The Major Problems

Volume and Velocity Engineering Problem

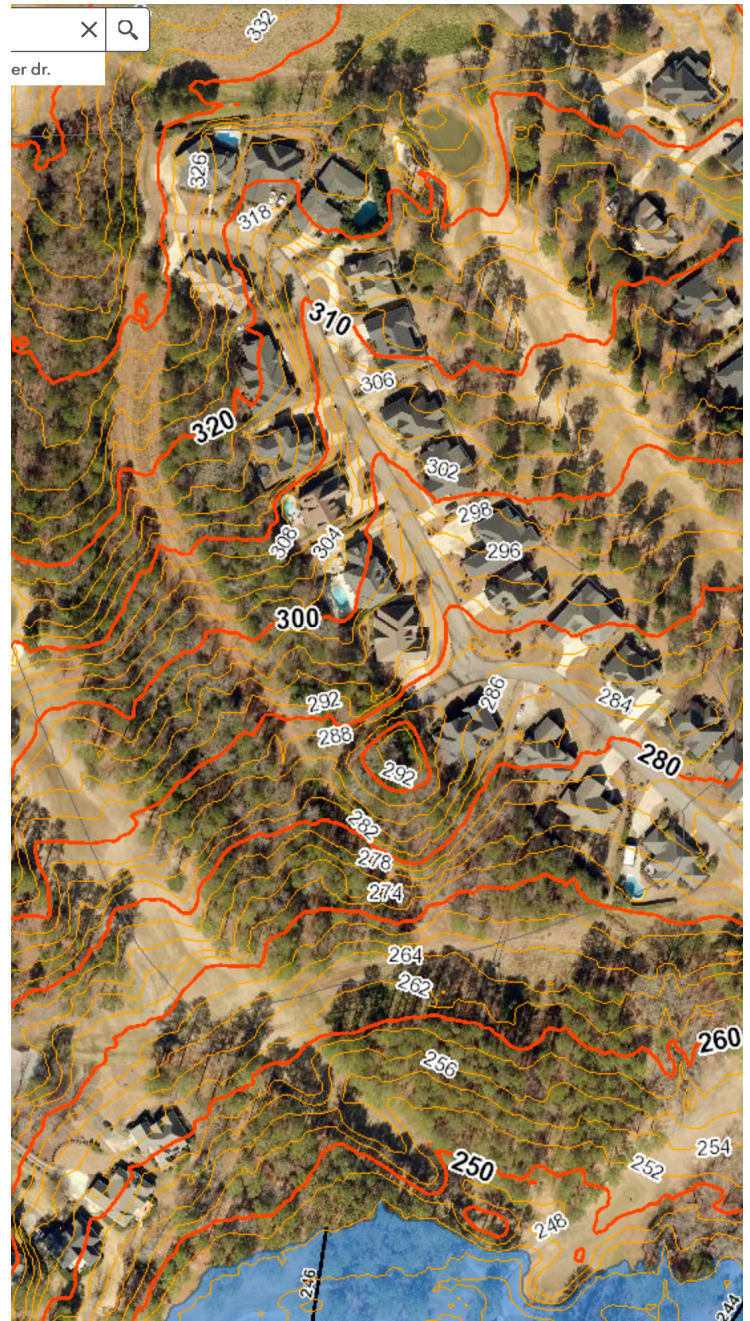
When taking the information provided by DHEC's reports on how to control silt it is evident that the planning and engineering was flawed from the start. The design of the project was contrary to nearly everything DHEC says about the issue of Volume and Velocity.

- Volume
 - A dirt road base run of over 1050 feet, and about 50' wide,
 - This equals 52,500 sq. ft. of unprotected dirt, which is over 1.2 acres,
 - On top of this the area, the sides of the road contain another 10 feet, or so, of mixed dirt and disturbed ground,
 - All of these areas are funneled into a lower roadbed, to create a flume for silt headed to a cul-de-sac area.
- Velocity
 - All of this water volume is being pulled down by gravity by a 1050 foot run sloping down 68 feet in elevation. This is a slope of about 1 foot drop for every 15.4 feet.

All of this Volume and Velocity is being met by one cul-de-sac area that is supposed to be designed to stop 80%, or more, of the silt carried by the watershed. After two tries there has not been a success yet, I don't know if it is possible with the Volume and Velocity problem.
